## MACHINE SERVICE BULLETIN NO. 127

SUBJECT: MA Model Power Unit

DATE: February 19, 1932

MACHINE SERVICE BULLETIN  
POWER UNIT FOR M.A. MODEL NO. 127  
30-794 X2

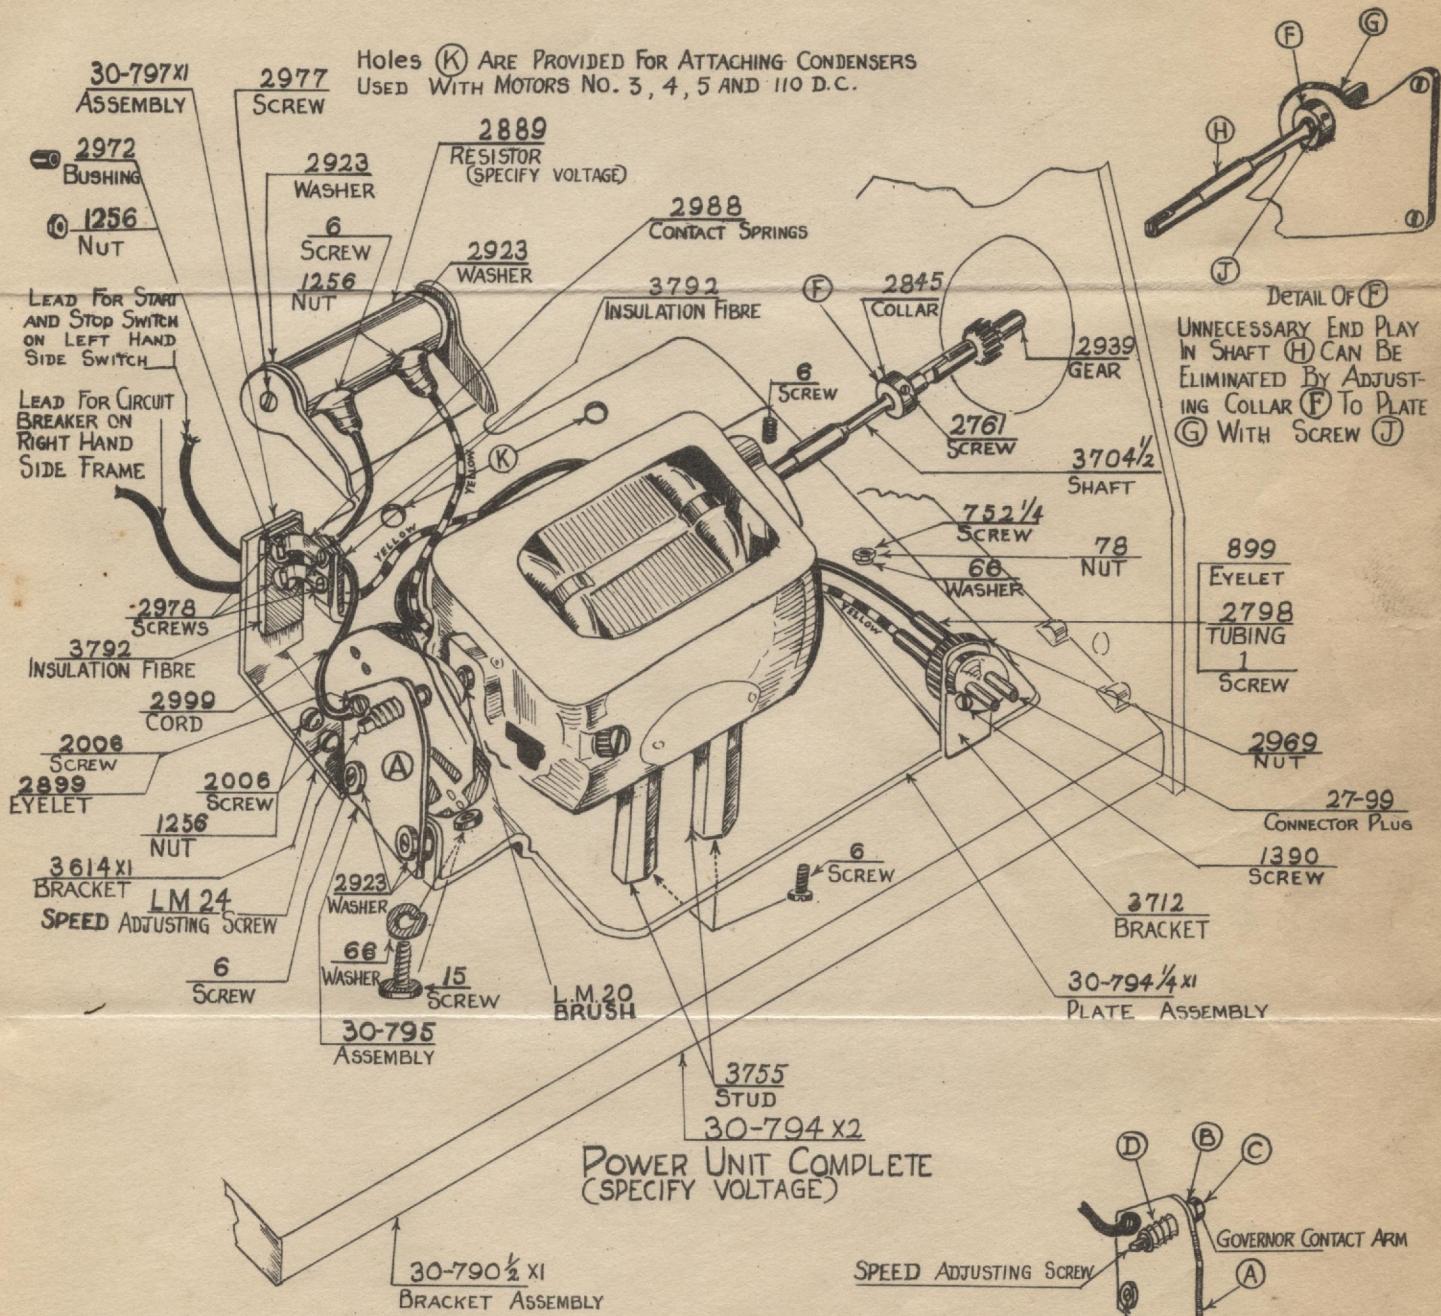
Adjust collar 2845 (F) with Plate (G).

Adjust contact bracket assembly 30-795 with governor contact arm (C).

ALIGNMENT OF CONTACT SCREW **D**  
WITH GOVERNOR CONTACT **C** AT **B** IS  
OBTAINED BY ADJUSTING BRACKET **A**  
WITH SCREWS **E**
